# COPART ADDITION WICHITA, SEDGWICK COUNTY, KANSAS

RE: SUB 2001-26 -- One-Step Final Plat of Copart Addition

RE: SUB 2001-26- One-Step Final Plat of Copart Addition

**CASE NUMBER:** SUB 2001-26 -- COPART ADDITION

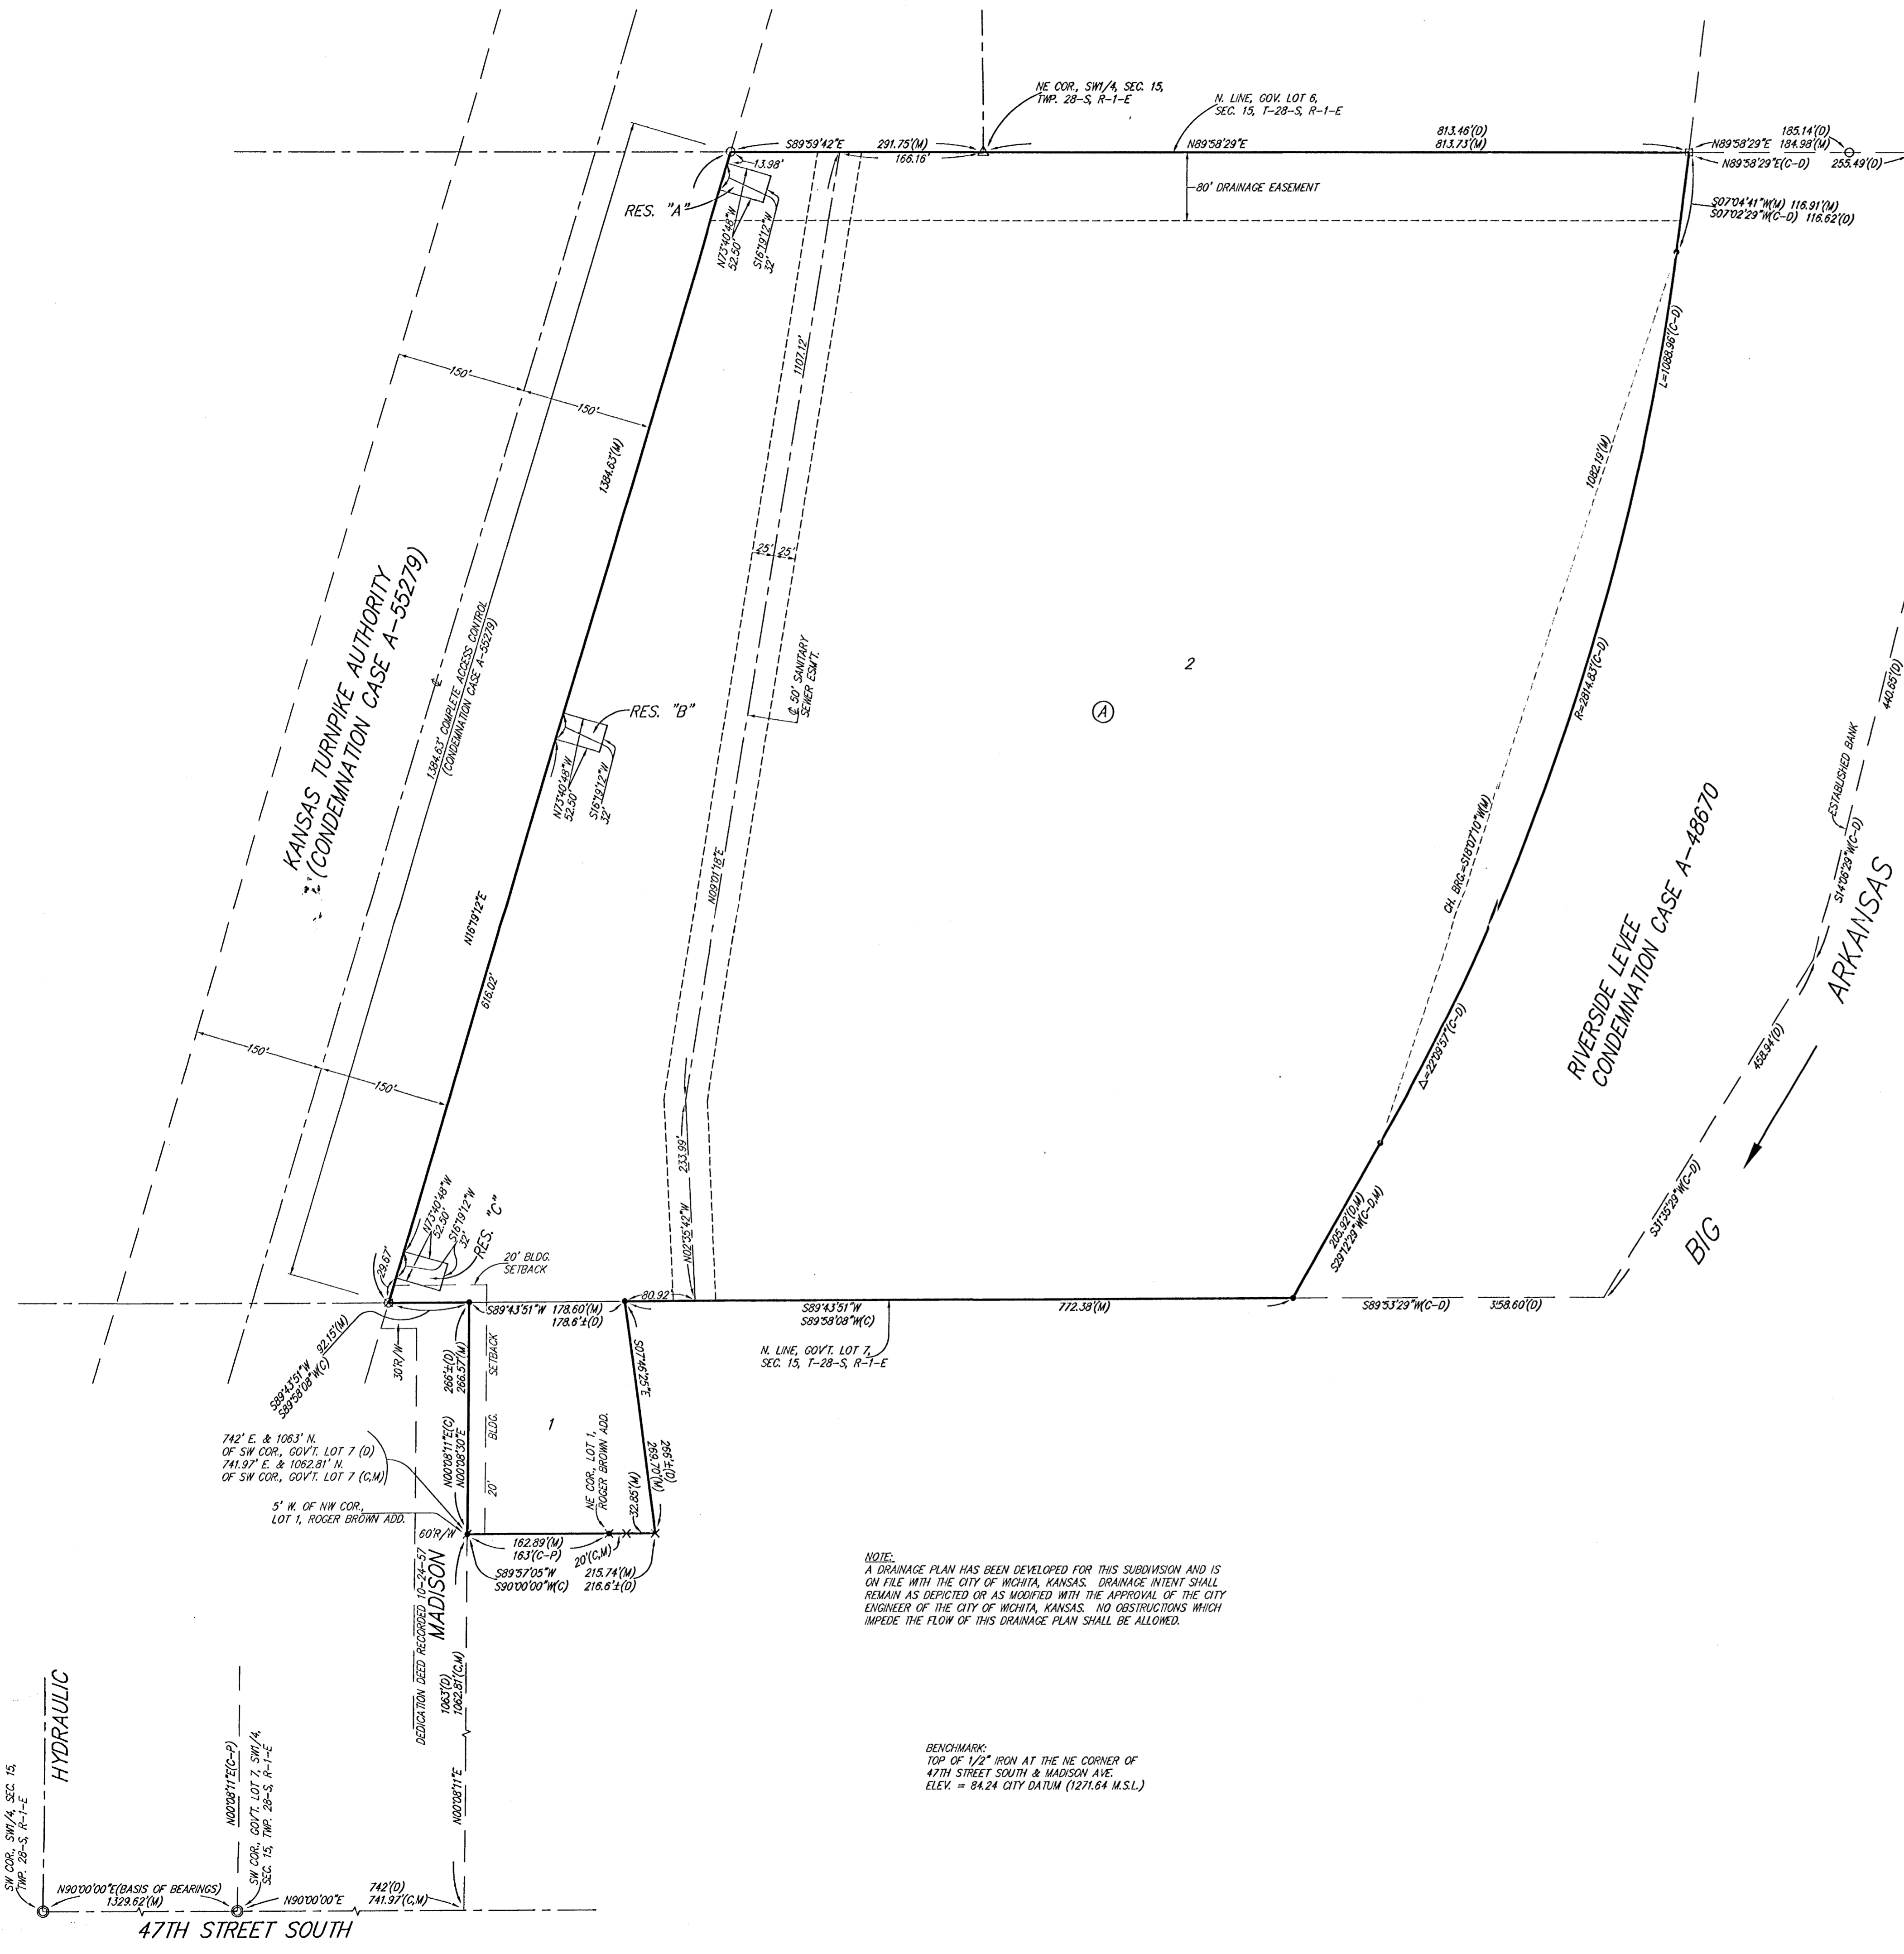
"The applicant shall dedicate an additional 10 feet along with both sides of the existing sewer easement. Also, a Restrictive Covenant shall be submitted addressing construction of the drive crossings over the easement."

- A. Sanitary sewer services are available to serve the site. The applicant shall guarantee the extension of City water. City Engineering needs to comment on the need for guarantees or easements. A guarantee for the extension of sanitary sewer is required.

- B. City Water and Sewer Department requests a 50-ft sewer easement and storage permitted only outside of the easement. The Subdivision Committee has approved a 30-ft easement to be utilized as a 30-ft drive aisle.

- D. City Engineering needs to comment on the status of the applicant's drainage plan. A 60-ft drainage easement is required along the north line of the plat.

- E. County Engineering requests that the plat reflect the established bank lines of Arkansas River.
- F. On the final plat, Reserves should be denoted to cover billboards and referenced in the plat's text.

- G. City Fire Department needs to comment on the need for the installation of a turnaround at the terminus of Madison. A hammerhead turnaround is required. The applicant shall submit a petition for future paving.

- H. Access controls dedicated along the Kansas Turnpike need to be denoted on the face of the plat.

- I. The southernmost structure situated within the required 20-ft zoning setback shall not be enlarged to increase its nonconformity and if removed cannot be replaced within the required setback.

- L. The platting text shall include language that a drainage plan has been developed for the plat and that all drainage easements, rights-of-way, or reserves shall remain at established grades or as modified with the approval of the applicable City or County Engineer, and unobstructed to allow for the conveyance of stormwater.
